TECHNICAL NOTE

Job Name: Horsham Transport Study – Regulation 19 Development Scenario
Job No: 332610655
Note No: TN001
Date: 12/04/2024
Prepared By: Norbert Moyo
Checked By: Robert D'Urula
Approved By: Paul Gebbett
Subject: Responses to Pre-Regulation 19 Consultation Queries

2. National Highways Comment Responses – Task 1a

Table 1: M23 Junction 11 Southbound Merge Assessment Flows (vehicles per hour)

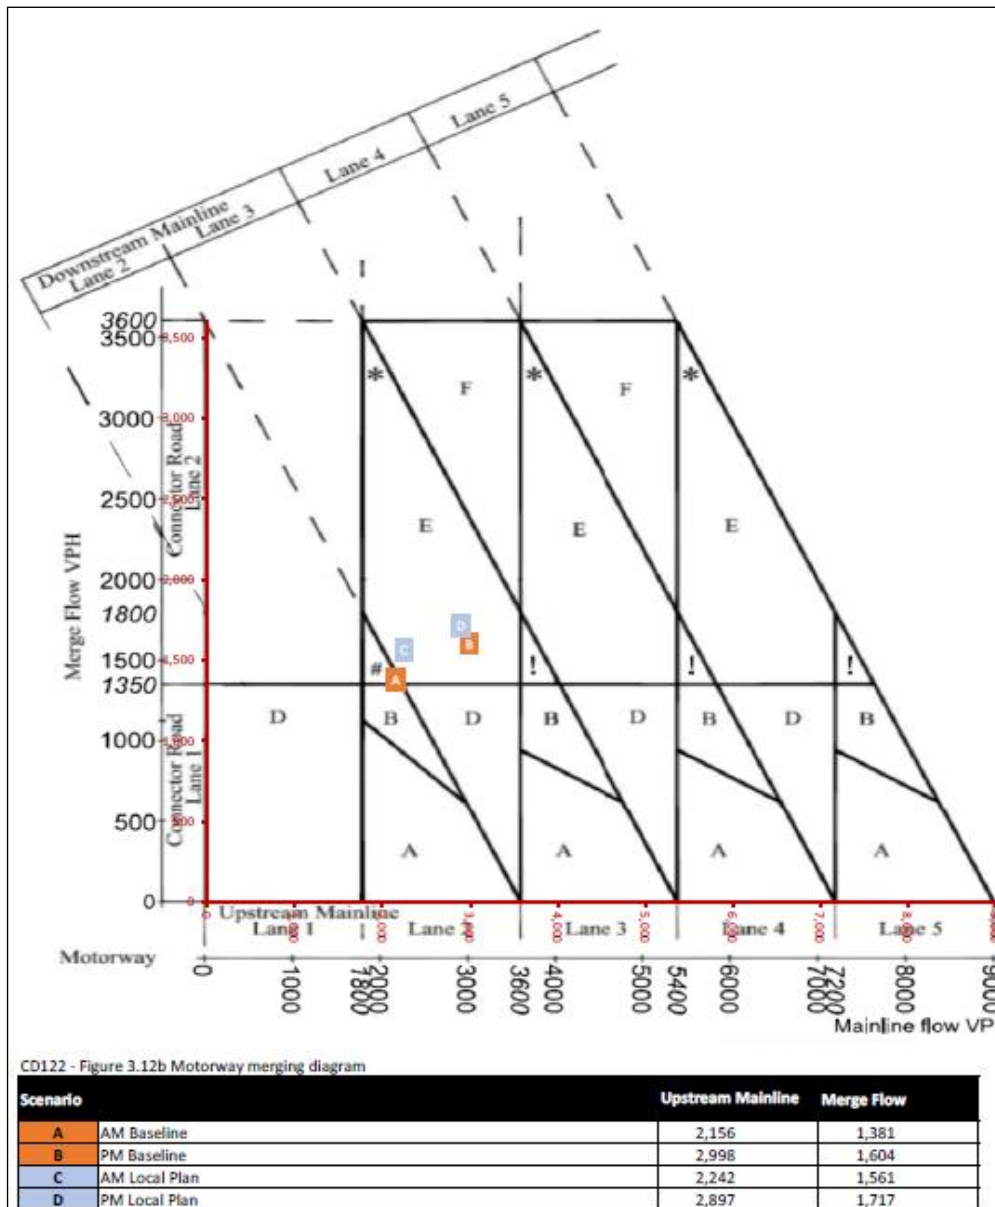
The summary results presented within the main document indicate that there is an expected change in requirements at the M23 J11 Southbound merge from rating B to rating E as a result of the Local Plan impacts. The TA states that “further consideration may be required”; we consider that additional information will need to be provided showing what a compliant merge layout would look like in this location. This will also need to include information relating to any physical constraints, such as land ownership, which would impact on the deliverability of any proposed solution.

- 2.6. In the AM peak, the southbound merge is shown as requiring a layout E in the Local Plan scenario in comparison to layout B within the Reference Case. It worth noting that in the Reference Case the merge flow of 1381 vph and the upstream mainline flow of 2156 vph places the merge type, labelled A in the figure above, in the area marked by the # symbol.

- 2.7. This indicates an area of uncertainty between Layout B and Layout E. Note 2 of Figure 3.12b CD 122, states that in this area of uncertainty, the choice of layout depends on the upstream and downstream provision and the ability for the mainline to accept the flows from the merge. The current Layout A has an upstream and downstream mainline capacity of 5,400 vph i.e. 1,800 vph/lane X 3lanes – see CD 122 paragraph 3.8. This mainline capacity is not exceeded by any of the flows predicted in the Reference Case or local plan in the analysis, and Layout B would be expected to be adequate in the AM peak in the Reference Case. This analysis therefore explains why Layout B has been selected in Table 2 above.

- 2.8. In the PM peak, the southbound merge is shown as requiring layout E in both the Reference Case and in the Local Plan scenario. This suggests that in the absence of the Local Plan generated traffic, there would be a need for Layout E, and with the Local Plan traffic added, does not require a different layout to that which would be required in the Reference Case. In both the Reference Case and Local Plan scenario, the PM peak flows are higher and hence would determine the capacity requirements. As has already been noted the predicted flows in both the Reference Case and the Local Plan scenario do not exceed the current available upstream and downstream mainline capacity of 5,400 vph.

- 2.10. Therefore, the impact of the Local Plan does not trigger the need for mitigation resulting from the additional Local Plan traffic. It is concluded that a revised Layout E would potentially be needed in future as a result of background growth and is not as a result of the LP development.

- 2.11. Were a Layout E required in the Reference Case and consequently the Local Plan, this would trigger the need for a lane gain to accommodate the merging flow. The flows in both the AM and PM peaks for both the Reference Case and Local Plan can be accommodated downstream within the existing 3 lanes hence there would be no justification for four lanes downstream. It would, however, be possible to reconfigure the existing merge layout as a lane gain into the existing lane 1 downstream.

Figure 7: A23 Hickstead Junction Flow Difference-AM Peak

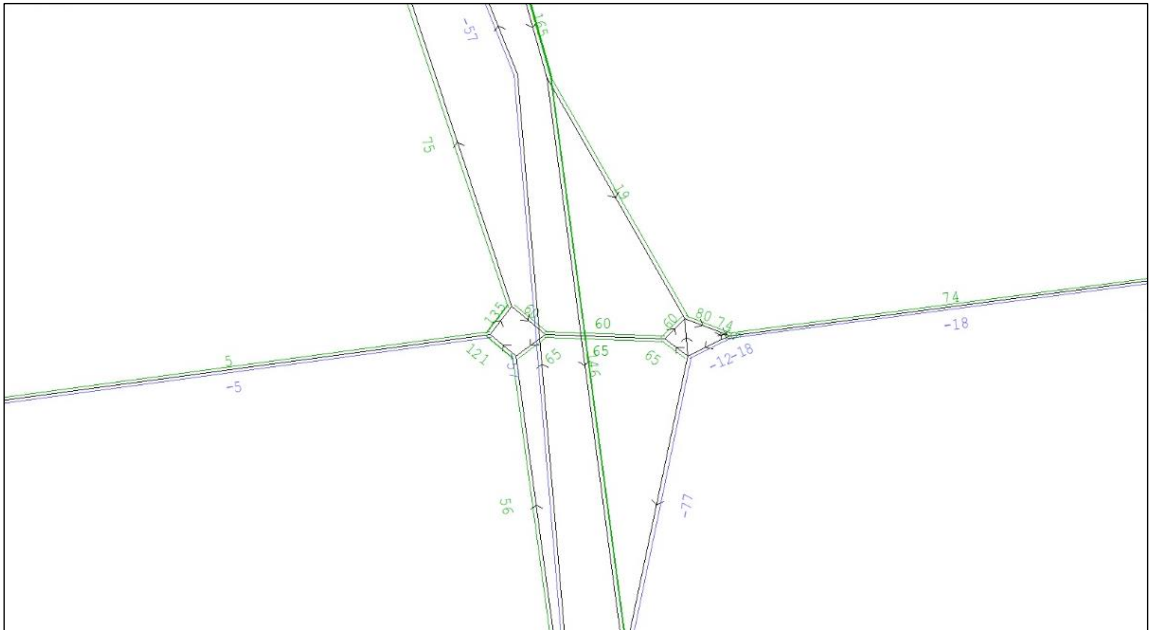
Based on this high-level appraisal, we would expect to see the traffic diagrams presented at Appendix G to include (as a minimum) the Pease Pottage and A23 / Bolney Road junctions, and additionally those junctions identified in Section 7 of the report as potentially requiring mitigation via revision of signal timings. If this is not currently the case, it is requested that these junctions be added to the relevant diagrams before publication of the Regulation 19 consultation materials.

- 2.20. Flow change diagrams at the Pease Pottage and A23/Bolney Road junctions and A23 Hickstead junctions have been provided below in **Figures 3 to 8**. These show the flow difference as Local Plan minus Reference Case. Green bandwidth implies an increase in flows with the Local Plan compared to the Reference case and blue bandwidth implies a flow reduction.

Figure 10: M23 J11 Pease Pottage LP sensitivity minus LP TA Flow Difference Flow Difference – PM Peak

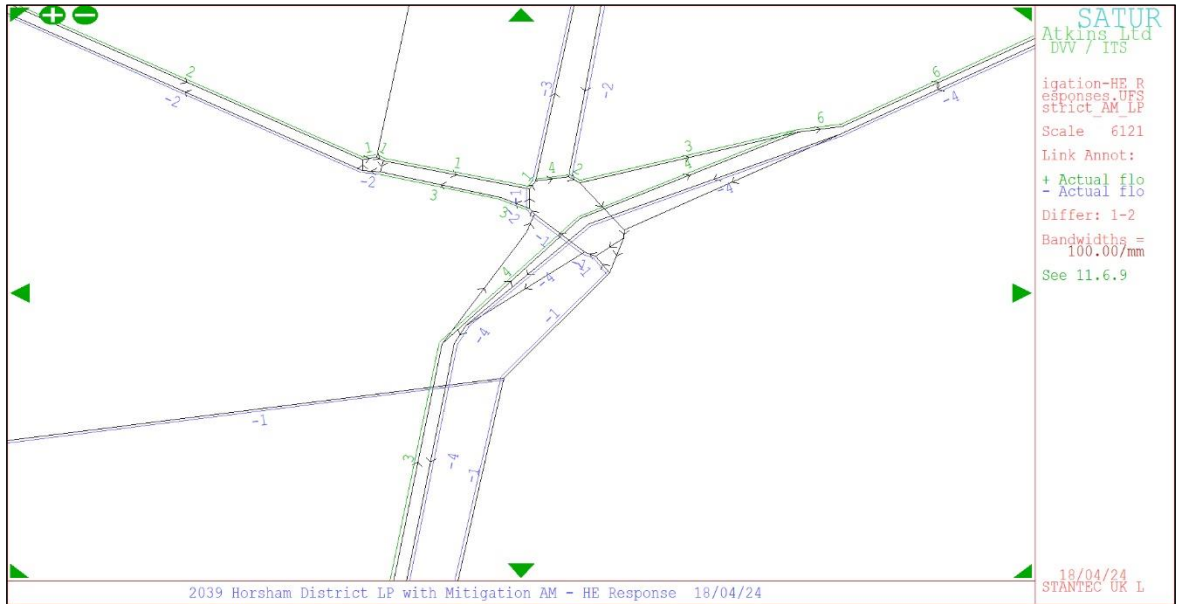
Further commentary should therefore be provided in relation to the assumptions made around the A23 Hickstead junction, in particular any anticipated impacts to the main interchange roundabout as a result of the identified changes to the mainline and junction flows. A test of the planned improvement scheme associated with the Burgess Hill business park, using the strategic model reference case and local plan flows, should also be undertaken (utilising the assistance of WSCC for access to existing junction models).

- 2.28. The modelling shows that any flow changes resulting from the sensitivity test are insignificant and therefore the results reported within the TA are still applicable. In the case of outputs relating directly to Hickstead junction, all the outputs from this sensitivity test are included in the responses to the previous queries above and are provided as Appendices A to D. For completeness a comparison of flows between the LP sensitivity test and the LP reported within the TA are shown in Figure 9 to Figure 14 which demonstrates the insignificant difference in the results. In the AM there are some noticeable flow changes in the sensitivity test compared to the LP TA model at the Hickstead junction, but as noted the flows reported in Appendices A to D are informed by the sensitivity modelling. Wider network flow changes between the LP sensitivity test and the LP reported within the TA can be found in Appendix H.
